Request for advice under S121[1][b] of the Building Act 2004

Address of Property:  
Four Canoes Motel, 273 Fenton Glenholme, Rotorua

**Section 121(a) Building Act 2004 advice on: Four Canoes Hotel - 273 Fenton Street, Rotorua**

*Photo 4: A Block – Manual call point [MCP]*

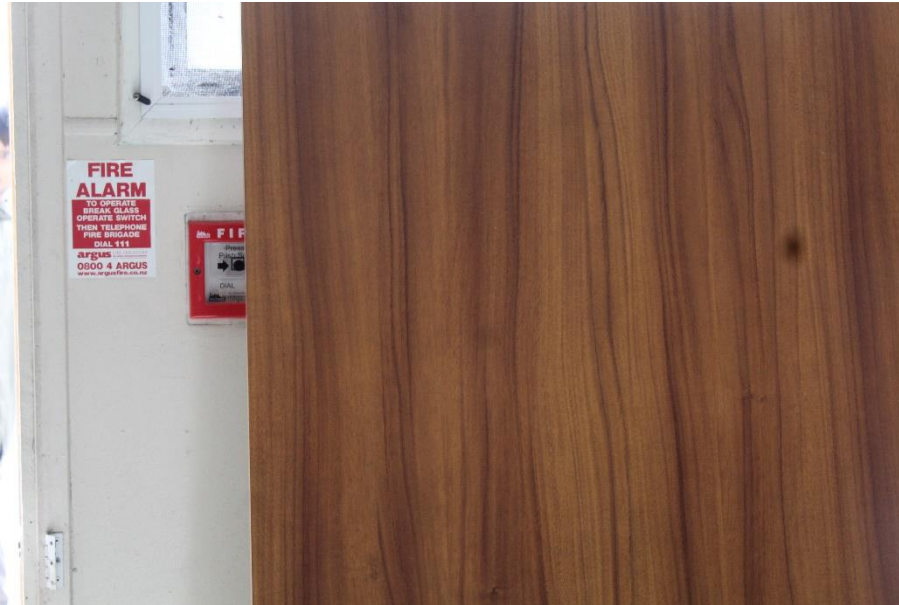
In A Block, I observed that combustibles obstructed an MCP.

*Photo 14: A Block, ground level*

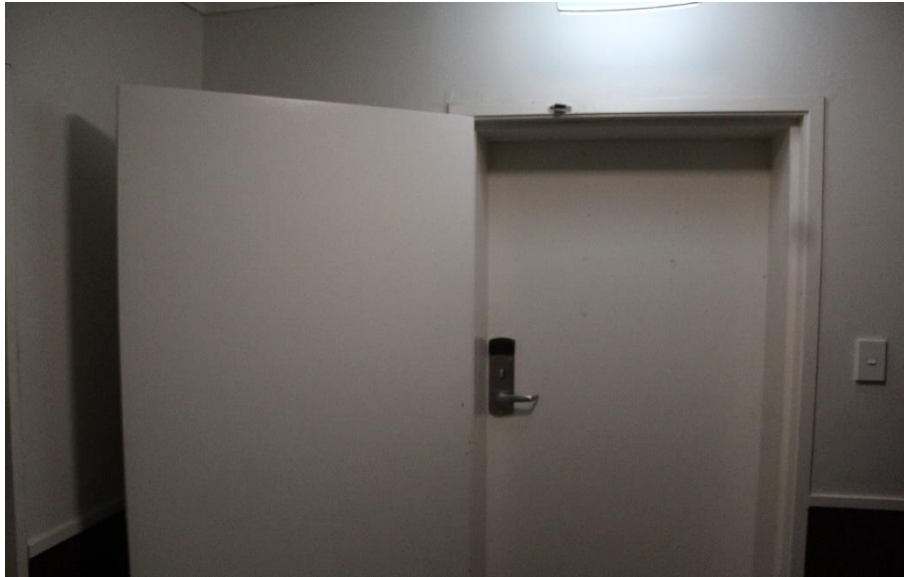
On the ground floor in A Block, I observed a set of doors that, at some stage, may have been designed to be smoke-stop doors. One side of the door had a self-closer installed on it. However, the other side that was open and [in the above photo] did not have a self-closer installed. The doors appear to be of solid construction like a smoke-stop door. However, there was no fire-rated glass installed in the window, which may have been replaced at some stage of its life.

It is recommended that all of the smoke-stop doors be assessed for suitability and consider installing hold-open devices that release upon activation of the fire alarm system. Mr Hoffman explained to everyone that this would require Council consent.

*Photo 15: A Block, upper level, escape route*

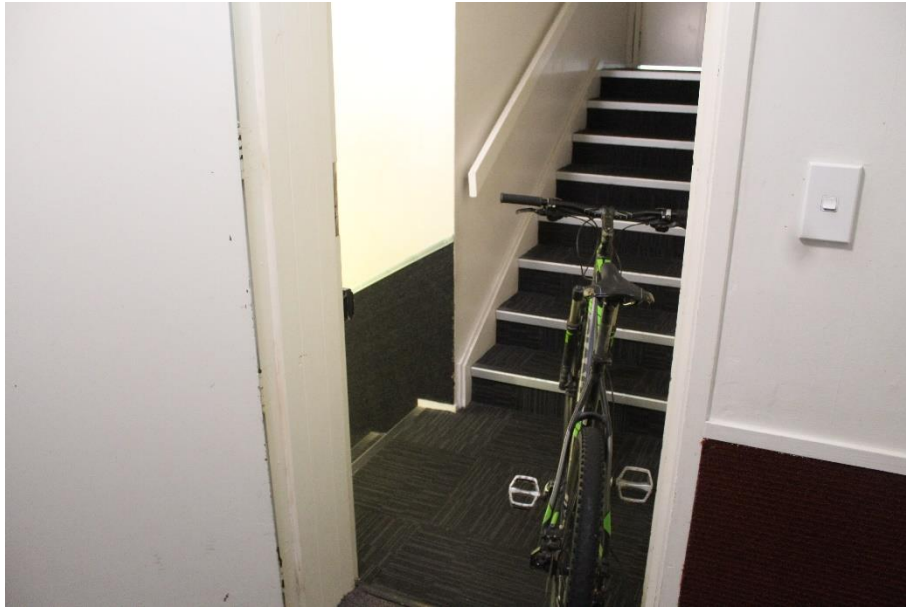
On A Block's upper level, I observed two solid constructed doors, one after the other. The first door opened inwards, directly followed by the second door that opened outwards. Given the thickness and construction of the doors, it was presumed that they were fire or smoke stop doors. However, opening doors different directions could easily lead to confusion in a smoke or fire-filled room.

Having these doors in a means of escape is generally not permissible under the relevant acceptable solutions. It is recommended that the owner engage a Fire Engineer who can assess these doors' suitability and make recommendations per the Building Act 2004.

*Photo 16: A Block, upper level, leading to upstairs accommodation and office.*

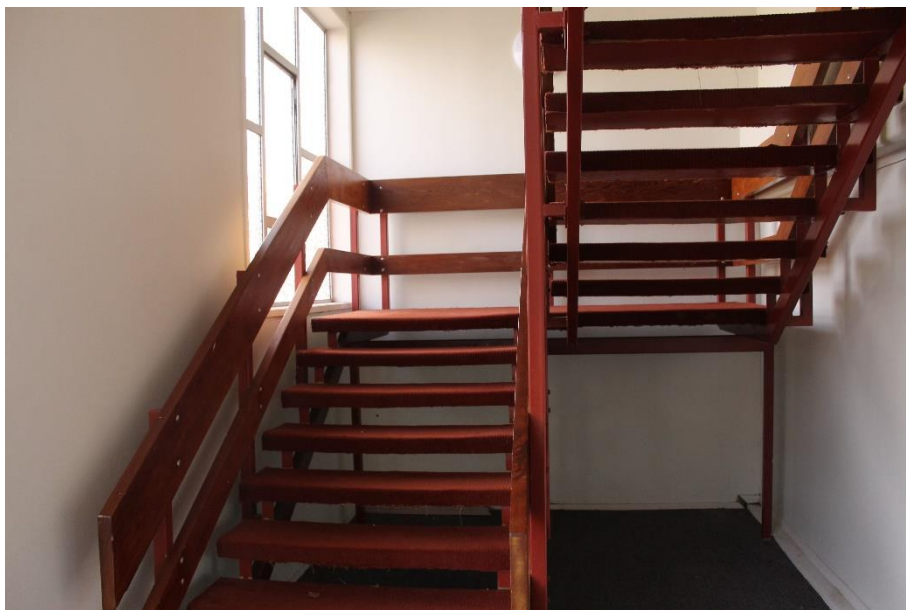
Once through the double doors in photo 15, I observed a bicycle stored in the escape route. The bike was also used to hold open one of the fire/smoke stop doors. All other escape routes were relatively clear from the storage of combustible items.

*Photo 19: A Block – Fire exit door, ground level*

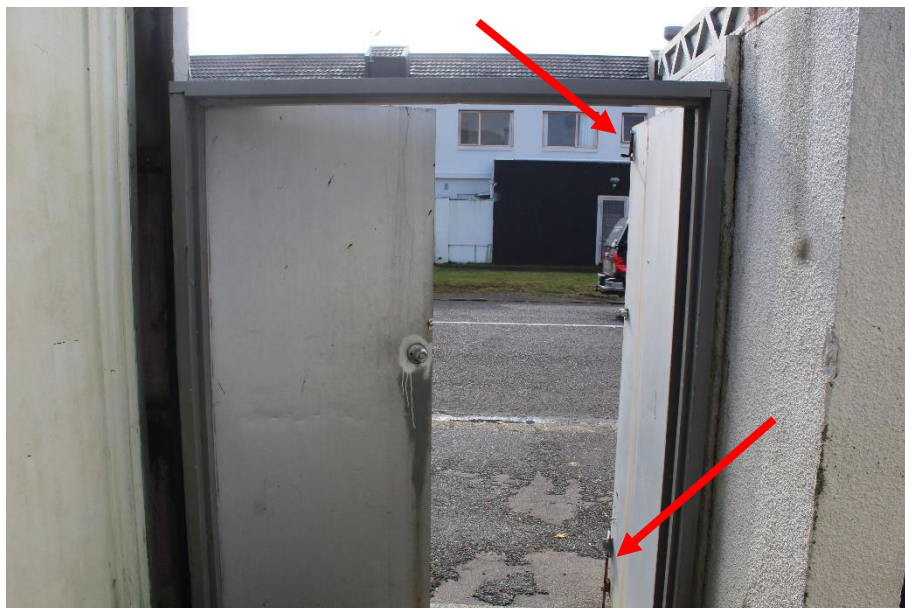
The fire exit in the above photo had two locking hardware that was not located in a convenient position, one at the bottom of the door and the other at the top of the door. I recommended that the current locking hardware be removed, and a crash bar be installed on these doors. This will ensure all occupants unfamiliar with the layout of the lock can easily operate the locking hardware and safely escape from fire.
